Access Compliance Report

Public Rights-of-Way

(Curb Ramps)

Intersection ID: 7423	Main Street: HUMBER_CT	Cross Street: SILCHESTER_LN	Location: NE
ADA ID: 829CAACEBA7F	Ramp Type: BlendTrans1	Initial Pass/Fail: Pass	Overall Compliance: No
		Severity Score: 7.5

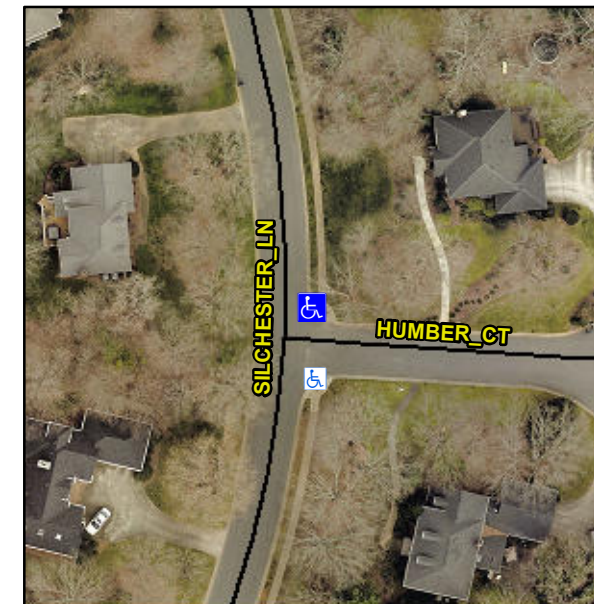
Not Found, R304.2.1, R304.2.2-Perp, R304.3.2-Para, R304.5.3, R305.2, R302.7.2

Remove & Replace Curb Ramp With Two New Directional Ramps or Equivalent. Remove & Replace Gutter.
